**MAINTENANCE
INFORMATION**

mi97-19

DATE: 26-08-97	SECTION: 18
SUBJECT: Stiffer spring for roof ventilation hatch

FIGURE 1: H3-45 ROOF VENTILATION HATCH

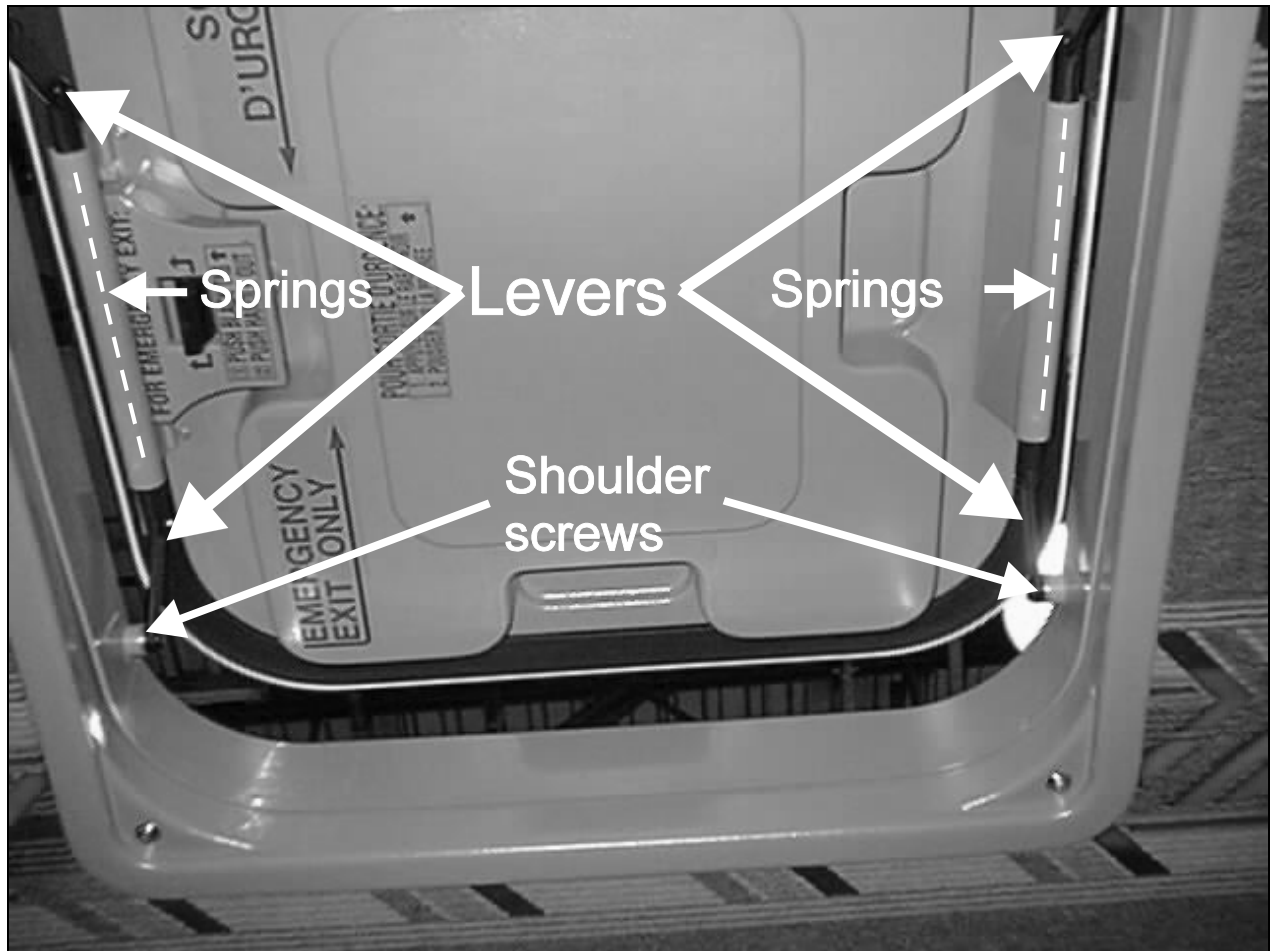
Certain road conditions may cause the roof ventilation hatch to open by itself. In order to avoid this inconvenience, a stiffer spring can be installed according to the next procedure.

1. Unscrew the shoulder screws of roof ventilation hatch.
2. Remove the ventilation hatch and the 4 springs located inside the hatch(Fig. 1).

Note: In order to remove inside springs, pull on the two levers on each side.

3. Install new springs (2 on each side).
4. Reinstall levers of roof emergency door as previously.
